Officer Report

Application Number:	HGY/2023/2360
Application Type:	Full planning permission
Address:	Block F (F1,F2,F3), Bounds Green Industrial Estate, London, N11 2UL
Proposal:	Demolition of existing industrial building and erection of replacement industrial building with associated hard and soft landscaping works.
Case Officer:	Josh Parker
Valid Date:	01/09/2023
Applicant:	c/o Agent
Agent:	Mr Aram Hekmat

Figure 1: Swept Path for Lorry

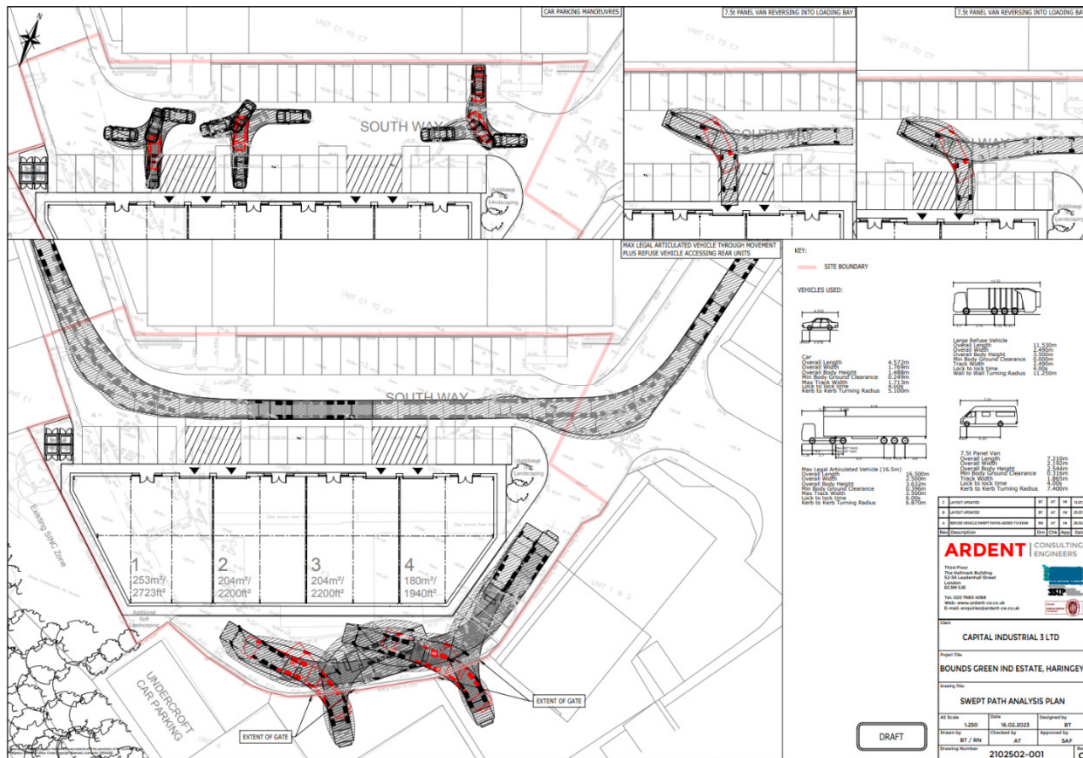
- 6.39 All delivery and services are proposed to take place within the yard area. Vehicles would access the site from Bounds Green Road, before entering Ring Way. Following this, vehicles would leave the site the same way as they entered. This arrangement would enable vehicles to access and leave the site all in forward gear. Such movements are considered appropriate and would allow the free flow of delivery and service vehicles through the site.
- 6.40 The Transportation Team has questioned the dimensions of the internal route through the site, with concerns being raised about possible manoeuvring implications for vehicles accessing the southern units. A swept path analysis has however been provided by the applicant and this is shown in figure 6. This demonstrates that large vehicles would be capable of moving through the site.
